## CIRCLIP Vs NUT

Renault Clio I All types

FI017EU

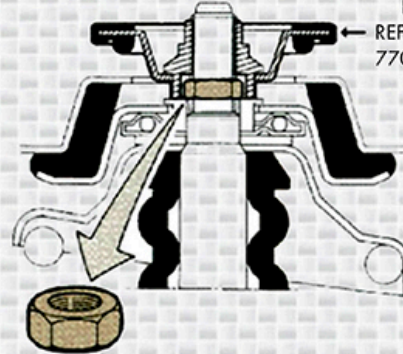
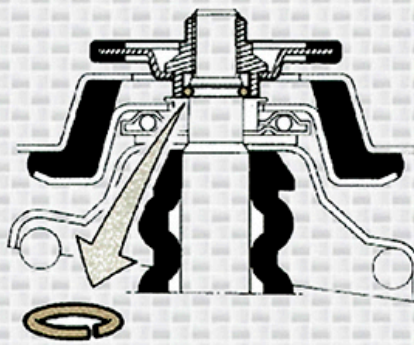
**ORIGINAL**  
... → 12.93

**ORIGINAL**  
1.94 → ...

**Discontinued**

**MONROE®**  
90 → ...

Shock absorbers  
11190(N/A) 11191(N/A)  
16190(N/A) 16191(N/A)  
Cannot be mounted on  
a 94 model car

New part numbers  
MONROE®  
E4220 11190(N/A)  
E4221 11191(N/A)  
16192(N/A)  
E4258 16193(N/A)  
(N/A): Discontinued

Tightening Torques	daNm.
Rod nut*	6
Intermediate nut	2.5
Lower mounting	11
